6.0 SCHEMATICS

SENSOR VHF TRANSMITTER BOARD

MCO ASSOCIATES, INC.
 1561 FORBES STREET
 FREDERICKSBURG, VA. 22405
 801 971 VHF RECEIVER w/ BOARD
 3325002
 Date: _____
 Drawn: _____
 Checked: _____
 Rev: _____
 3/1/80

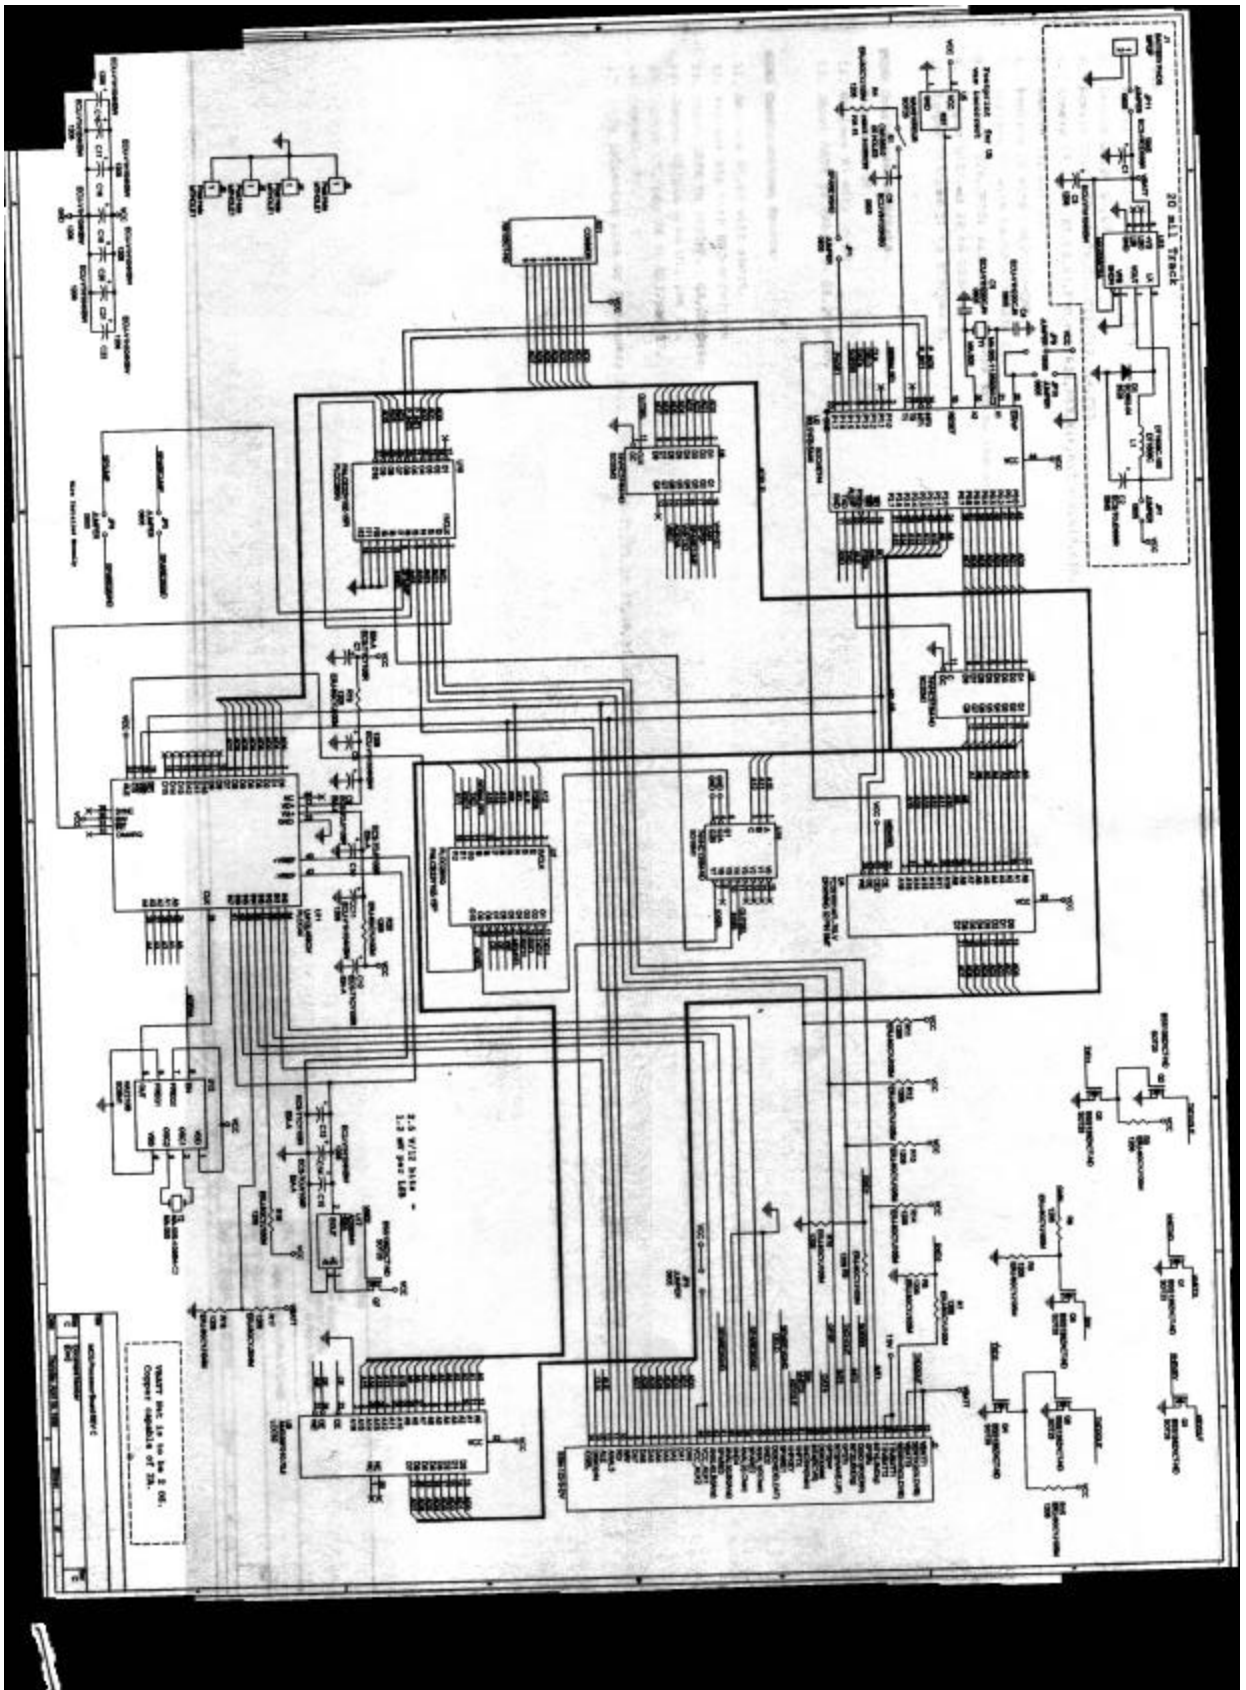
ERRATA:

1. Rotate V2 (reset) clockwise 1 pin.
2. Replace L5 with 22 uf 50V35P-223 (only if using onboard S volt supply) U10 with longer leads at 4th, use single supply for now (change on new board)

3. Add 100K pullup to J76 pin 10
4. J1, J5 shield and signal backwards (correct in external wiring)
5. Change R5, R10, R11 to 10K
6. Change R12 to 10K, correct connection now

7. U11 LIFT pin 5 and connect to 4 or switch to 9430
8. Remove R15 and R24
9. Connect U4, R6 to U01, J28 (Acht to RWY)
10. Connect U12, R13 to U01, J28 (Acht to RWY)

11. L47F U01-06 and short to 94 (GND)
12. L47F U01-05 and move to 94 pad
13. L47F U01-103 and short to J27
14. Remove U1
15. Add 100K pullup (R29 20.23 888 on top of PAD9, M03C118 chip (R29 to board))

16. Connect 2 crystal pins to U01-2,3
17. Remove C6,C7
18. Add 1.1 uf inductor. Connect U0-3 to Inductor
19. Add 1.1 uf inductor. Connect U0-4 to Inductor

20. Connect U0-1 to GND pin 20 (VCC)
21. Connect U0-4 to GND
22. Connect U0-8 to VCC
23. Connect outside pad of old oscillator to inside side of C24
24. Connect other side of capacitor to GND.

25. Connect other side of capacitor to GND.
26. Disconnect U0-40 for use of clock (L11F)
27. Add 100K pullup to J76 legs (R3-2,4,10,14)
28. Pinout, footprints are backwards need to be switched (no change)

29. Add 100K pullup to J76 legs (R3-2,4,10,14)
30. J17 U02-23 and tie to GND
31. J17 U02-21 and tie to VCC
32. J17 U02-19 tie to VCC
33. J17 U02-18 tie to VCC

34. Take out U20, tie pin 1 and 4 together on board. tie pin 4 to GND
35. Add 10 pf cap between pins 54 and 56 of U9

- U01 - connect all 3 pins
 - U02 - U01-39 to U0-71
 - U03 - U01-5 to VCC
 - U04 - U01-6 to VCC
 - U05 - U01-8 to VCC
 - U06 - U01-9 to VCC
 - U07 - 1-2 install
 - U08 - 1-2 install
 - U09 - install J28G only
 - U10 - install head only
 - U11 - short 1 to 2, 5 to 6, 9 to 10, 13 to 14
 - U12 - to GND
- All others no install.

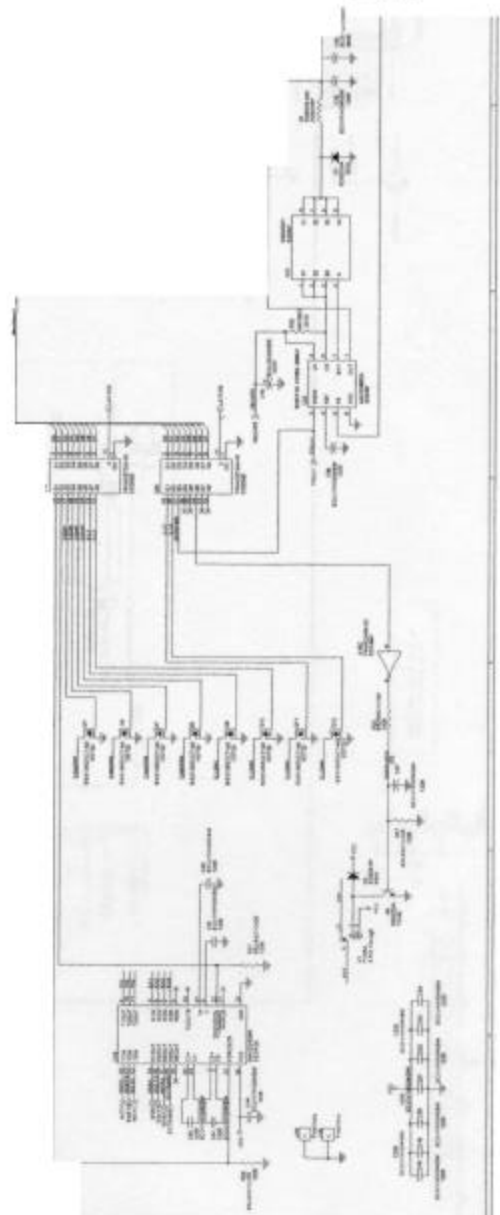
- for VCC type system
1. U07 type system
 2. L47E pin 13 and 13 from pin 13
 3. L47E pin 1 from pad and connect to U02 pin13
 4. Connect U02-10 to pin 27 of 44 pin connector (J4)
 5. Cut lead from U0-12 and connect pin to U02-4
 6. Connect U02-17 to U02-14 (GND)
 7. Connect U02-17 to U02-14 (GND)
 8. L47E U02-9 and connect to J4-16
 9. Connect U0-93 to U02-13
 10. Connect U02-4 to J4-18
 11. Connect U02-4 to J4-18
 12. Connect U02-4 to J4-18
- set rid of H161, connect camera direct to 7111

REV A Errata:

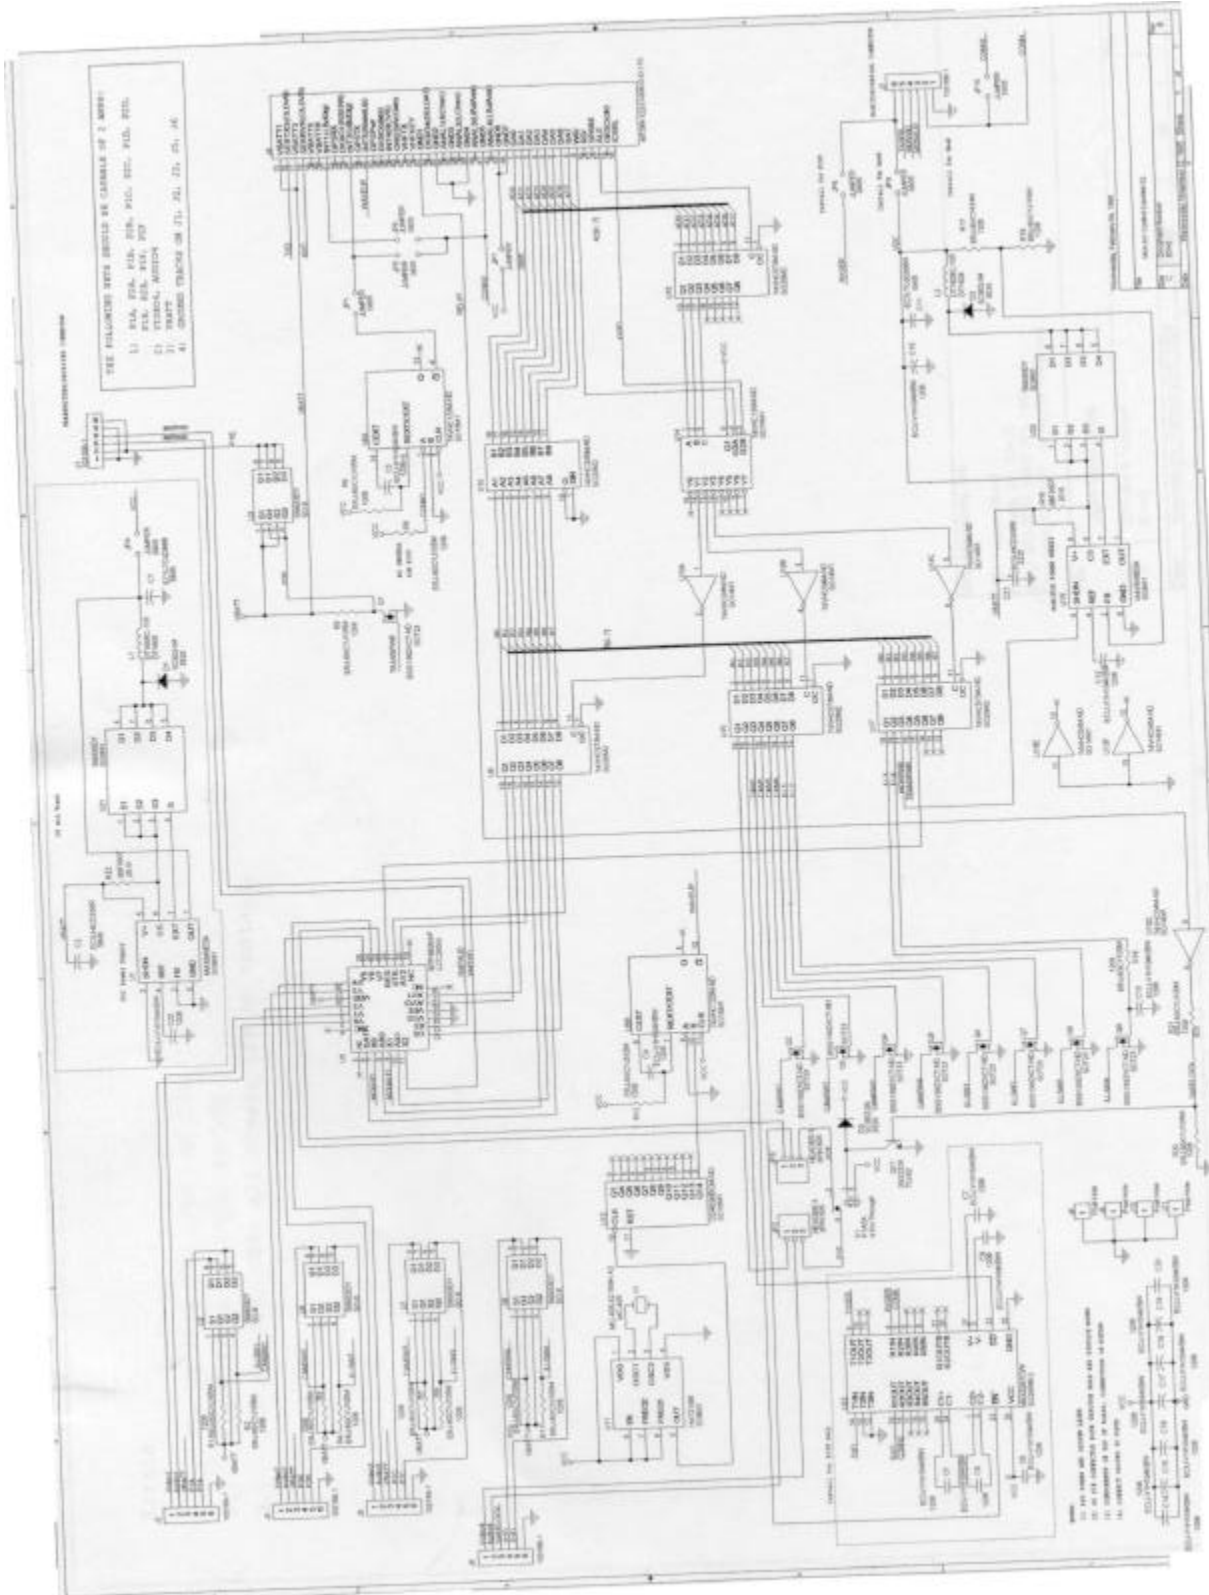
- 1.) Jumper U0/pin 41 to U0/pin 87 (move PAD_09 set to U0/pin 87).
 - 2.) Jumper U1/pin 15 to M02/pin 13 (tie RT/RT set to VCC through pullup)
 - 3.) Jumper U0/pin 15 to M02/pin 13 (tie RT/RT set to VCC through pullup)
 - 4.) U0 part number is incorrectly use M12-M103237.
 - 5.) J2/pin 3 is wrong net; should be VCC.
 - 6.) J2/pin 5 is wrong net; should be VCC.
 - 7.) J2 is placed too close to post hole to allow PAD programmer connector to connect.
 - 8.) Footprints/orientation is incorrect.
 - 9.) For production, remove J241. Install Jumper J241-2.
 - 10.) Disconnect WR net from U0/pin 37.
 - 11.) Run VSW to U13, U14, U16, U17 instead of VSWRT. 12.) Add JUNCTION to VCC's at U8
 - 13.) Add JUNCTION to VA at C18
 - 14.) Removed pullup from U00 at M0
- up in white track is on

| Type | Document Number | Rev |
|------------------------------------|-----------------|------|
| Digital Video Errata | | |

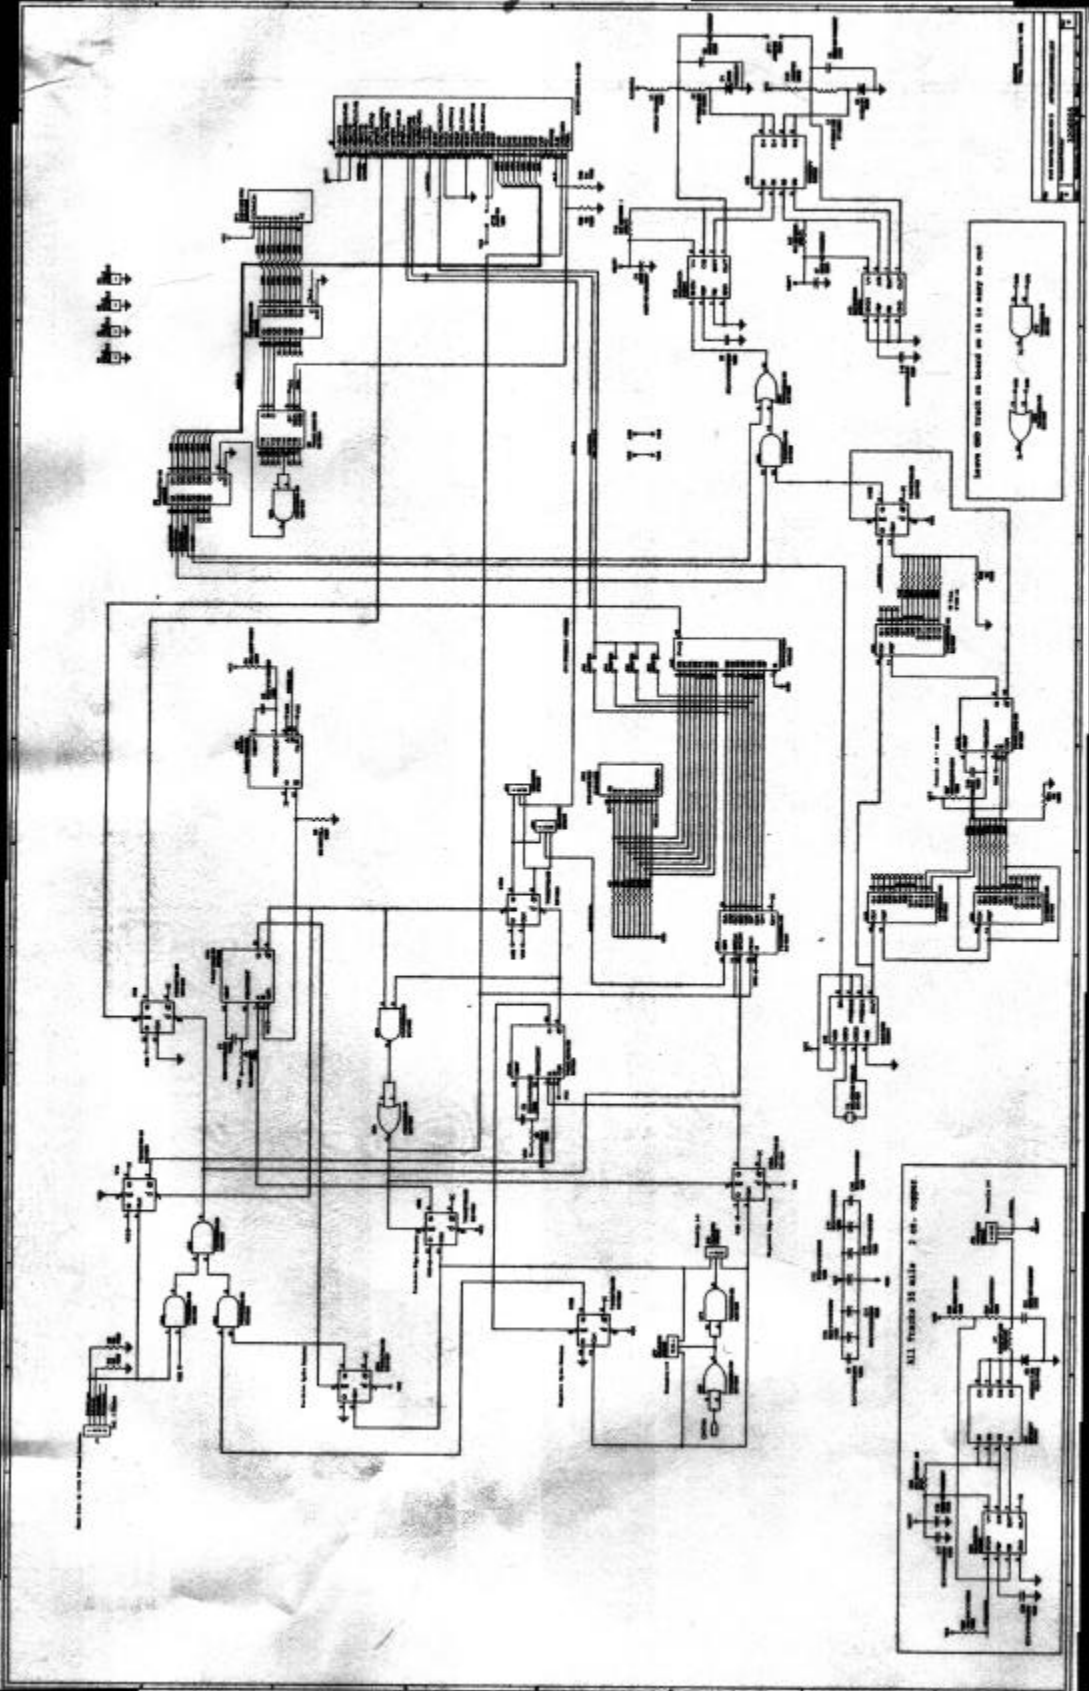
Errata:

- 1.) Tie U22/Pin 23 (/EN) to GND.
- 2.) Tie U22/Pin 22 (/SD) to VCC.
- 3.) Install JP7, JP8; all others are no install.
